**SUBJECT:** **Customer Satisfaction Program 21B42 – Supplement #1**  
 Certain 2020-2021 Model Year F-350 to F-550 Ambulance and Wrecker Vehicles  
 Equipped with a 6.7L Diesel or 7.3L Gas Engine  
 Certification Label and Front Spring Mismatch to Order Guide

**REF:** **Customer Satisfaction Program 21B42**  
 Dated: July 13, 2021

**New! REASON FOR THIS SUPPLEMENT**

**FIGURE 2**

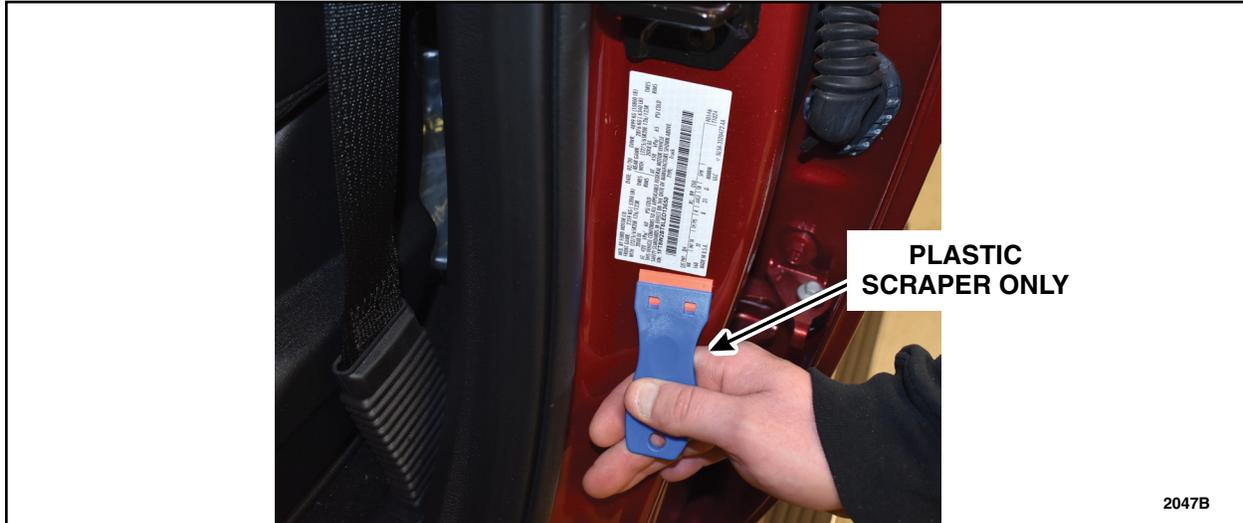
- Note orientation of the label on the driver side B-pillar.
- Using a plastic scraper, remove the Safety Certification label. See Figure 2.

**NOTICE: Do NOT use a metal scraper tool, this could cause paint damage.**
